EAST LIMERICK SUBSTATION DEVELOPMENT

Road Safety Audit Stage 1/2

Project Title	Proposed Substation at East Limerick
Project No.	25232-02
Document Title	Road Safety Audit Stage 1/2
Document No.	25232-02-001

Figure 2.7 – Skewed Angle

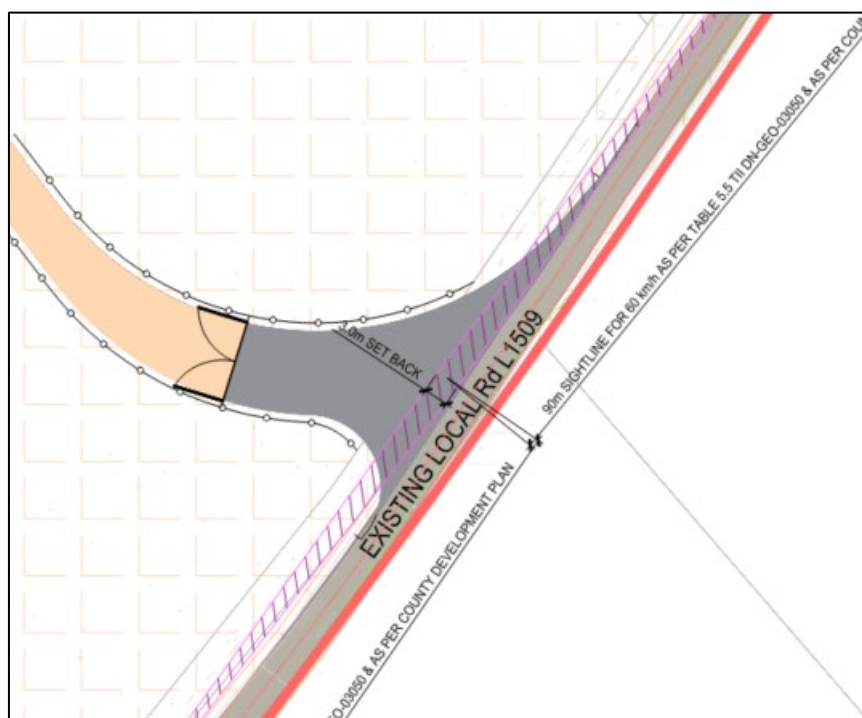
2.1 Problem: Skewed Angle

Location: Substation Access

The proposed development access intersects the local road at a skewed angle rather than at, or close to, a right angle. As a result, drivers exiting the development will be required to look back over their right shoulder to observe approaching traffic on the local road. This manoeuvre may reduce the effectiveness of driver observations and compromise intervisibility between exiting and approaching vehicles. Consequently, the likelihood of missed observations and vehicular conflicts may be increased.

Recommendation: Revise the alignment of the proposed development access to form a junction angle as close as practicable to 90 degrees with the local road.

Figure 2.8 – Vehicle Over-run

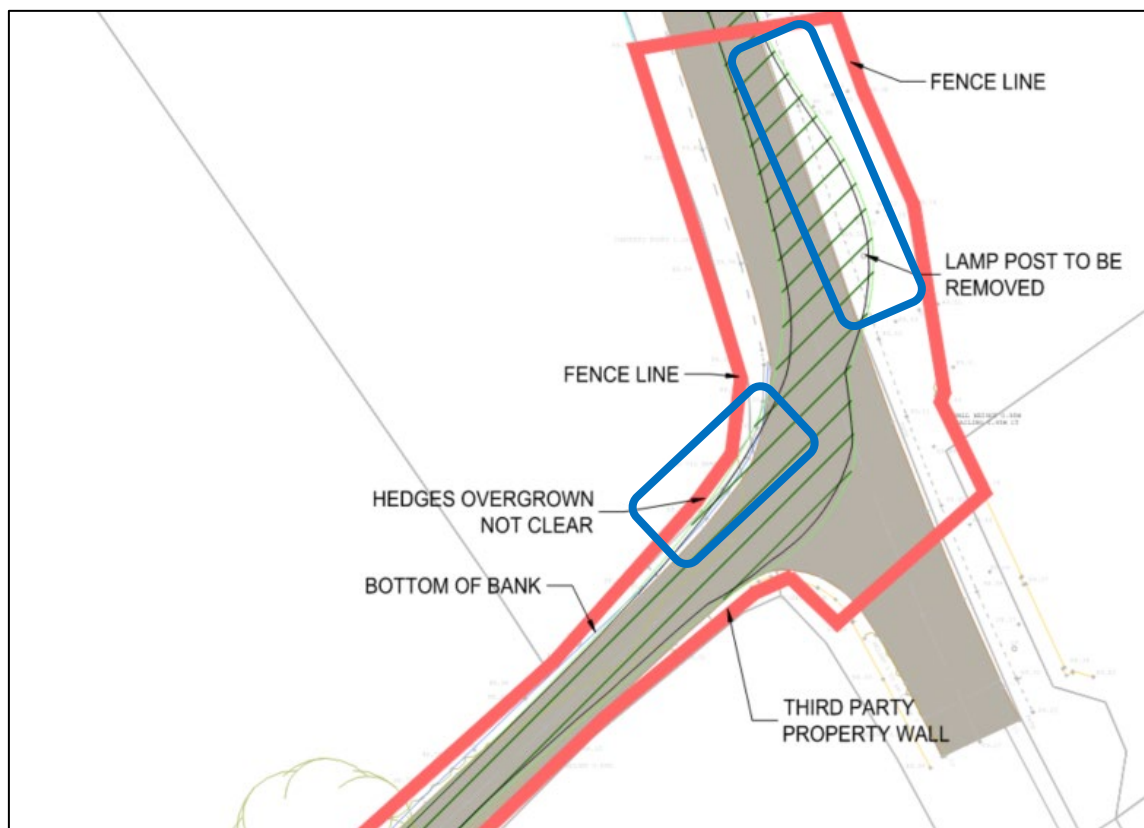
2.2 Problem: Vehicle Over-run

Location: R513/L1509 Junction

Swept path analysis indicates that the proposed delivery vehicle overruns the existing footpath and carriageway edge at the R513/L1509 junction during turning manoeuvres. As a result, pedestrians using the footpath may be at increased risk of conflict with turning vehicles. Repeated overrun of the footpath may also result in damage to the footway surface, potentially creating trip hazards for pedestrians. In addition, vehicle overrun of the carriageway edge may increase the risk of loss-of-control collisions and damage to the road infrastructure.

Recommendation: Review the junction layout and vehicle access arrangements to ensure that the design delivery vehicle can complete the required turning manoeuvres without overrunning the existing footpath or carriageway edge. Where this cannot be achieved, appropriate measures should be provided to mitigate the risk to pedestrians and other road users.

Paragraph No. in Safety Audit Report	To Be Completed By Designer			To Be Completed by Audit Team Leader
	Problem accepted (yes/no)	Recommended measure Accepted (yes/no)	Describe alternative measure(s). Give reasons for not accepting recommended measure. Only complete if recommended measure is not accepted.	Alternative measures or reasons accepted by auditors (yes/no)
2.1	Yes	Yes. The access has been revised to form a junction angle of 70 degrees as per DN-GEO-03060. This provides a less skewed junction angle, while still facilitating the vehicle movements associated with the transformer delivery. This is shown on drawing no. 251014-SS-X-X-XXX-DR-CE-1200.		
2.2	Yes	Yes. The drawing has been updated to show temporary road widening measures to facilitate the vehicle movements associated with the substation delivery. This is shown on drawing no. 251014-SS-X-X-XXX-DR-CE-1201.
